Project	IEEE 802.16 Broadband Wireless Access Working Group < http://ieee802.org/16 >	
Title	Clarify downlink burst profile change management	
Date Submitted	2005-01-20	
Source(s)	Chi-Chen Lee Tzu-Ming Lin Yu-Ren Yang Industrial Technology Research Institute, Computer and Communications Research Labs, Taiwan Bldg. 11, 195 Sec. 4, Chung Hsing Rd. Chutung, HsinChu, Taiwan 310, R.O.C.	Voice: 886-3-5914579 Fax: 886-3-5829733 mailto: jjlee@itri.org.tw mailto: TMLin@itri.org.tw mailto: yryang@itri.org.tw
Re:	IEEE P802.16-REVd/D5	
Abstract	This contribution introduces clarifications for DL burst profile change management procedures.	
Purpose	Adopt into P802.16d/D5 corrigenda	
Notice	This document has been prepared to assist IEEE 802.16. It is offered as a basis for discussion and is not binding on the contributing individual(s) or organization(s). The material in this document is subject to change in form and content after further study. The contributor(s) reserve(s) the right to add, amend or withdraw material contained herein.

Clarify downlink burst profile change management

6.3.10.1 Downlink burst profile management

Figure 79—Transition to a more robust burst profile

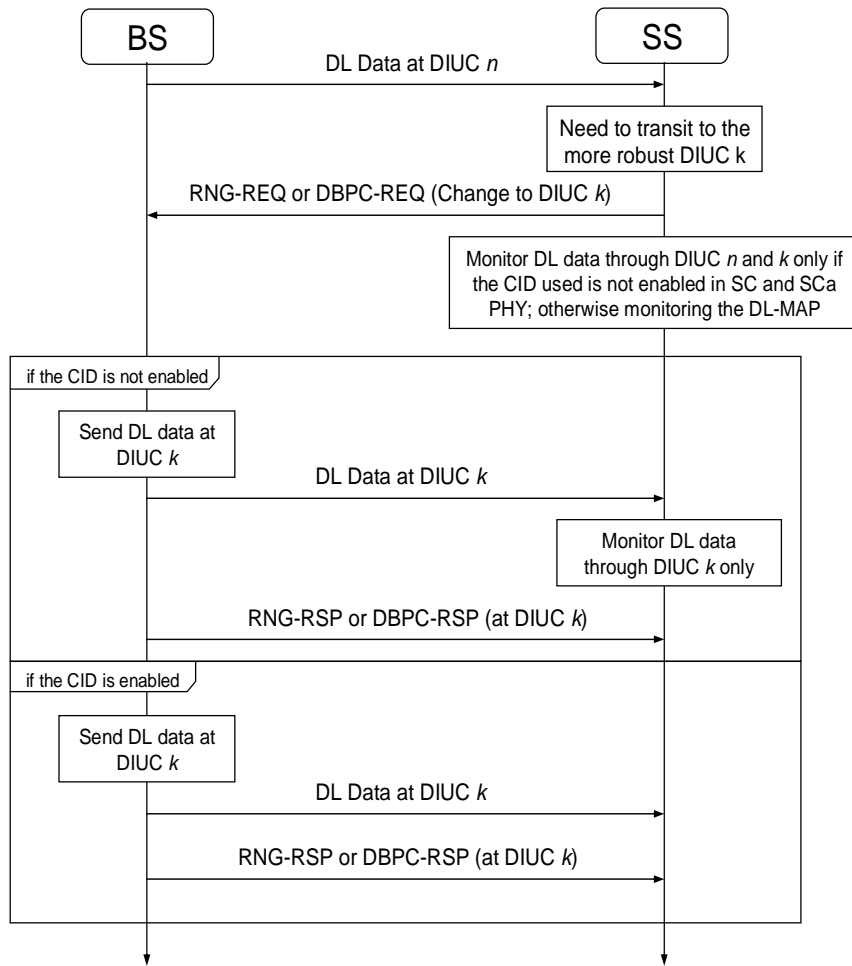
In IEEE P802.16-REVd/D5 “Figure 79 —Transition to a more robust burst profile” and “Figure 80— Transition to a less robust burst profile”, the SS must monitor DL data through two different DIUC while changing the DL burst profile. This scenario is reasonable only if the *CID used* is **not** enabled by burst profile for SC and SCa PHY (see Table 139 and Table 190). In the case of OFDM, OFDMA PHY and in the case of SC, SCa PHY that the *CID used* is enabled by burst profile, the SS’s basic CID is included in each DL-MAP_IE. Thus, the SS can check the DL-MAP for its basic CID and know what DIUC it should use. This design improves the energy efficiency of the SSs that have power consumption constraints. Due to the lack of consistency between this design and the procedures defined in specification, we provide two modified figures to clarify this issue.

[Replace Figure 79 and Figure 80 with the following figures.]

Figure 81—Wait for response during change of DL burst profile—SS

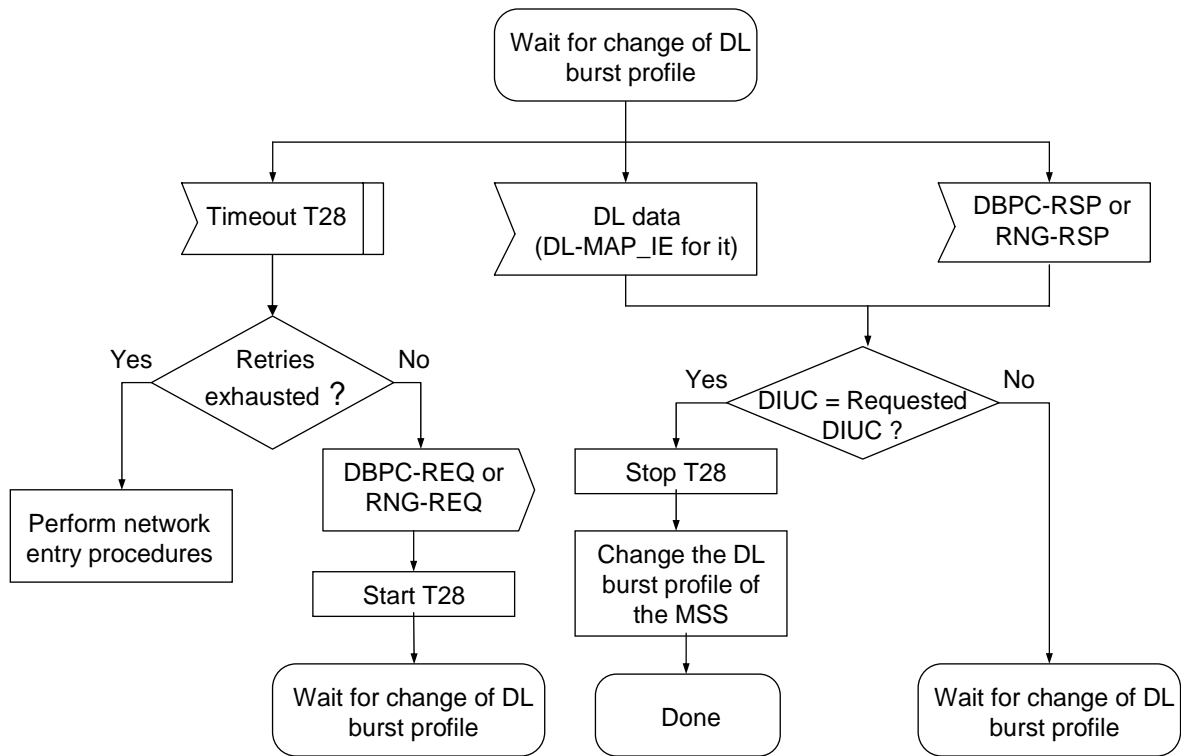
We notice that DL burst profile management does not mention how the SS deals with the lost of the change request. However, the change request may be lost due to the contention or harsh mobile environment. Therefore, the additional flow chart (see Figure 81a) is proposed to make the change of DL burst profile more robust. The new timer T28 is designed for handling the lost of the DBPC-REQ or RNG-REQ during the change of DL burst profile. Note that the BS should send DL data at new DIUC or send the DBPC-RSP or RNG-RSP to the MSS before T28 times out.

[Insert new figure after Figure 80.]
